4.17.18	CHANGE AS PER ECN 18-021	A
DATE	DESCRIPTION	REV.

KEYSTONE ELECTRONICS CORP.			
www.keyelco.com • NEW HYDE PARK, NY 11040 • Tel (516) 328-7500			
PART NAME			
.250-32 NUT			
MATERIAL			
BRASS			
FINISH		DRN BY	DATE
NICKEL PLATE		BOONE	11.05.99
		APP'D	SCALE
		LN	3X
TOLERANCES	INCH [MM]	CODE	DWG NO.
DECIMAL	± .005 [± 0.13]	C	6095-2
ANGULAR	± 1°		
UNLESS OTHERWISE SPECIFIED

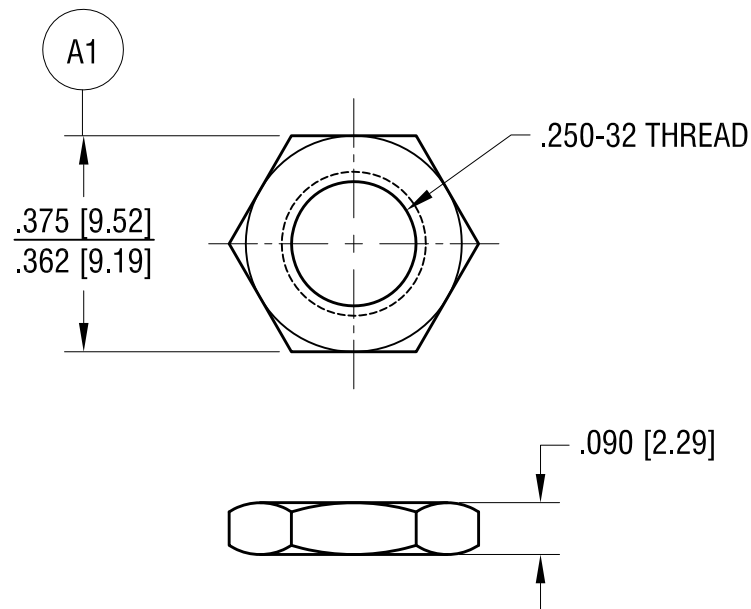
(A1) WAS .375±.005
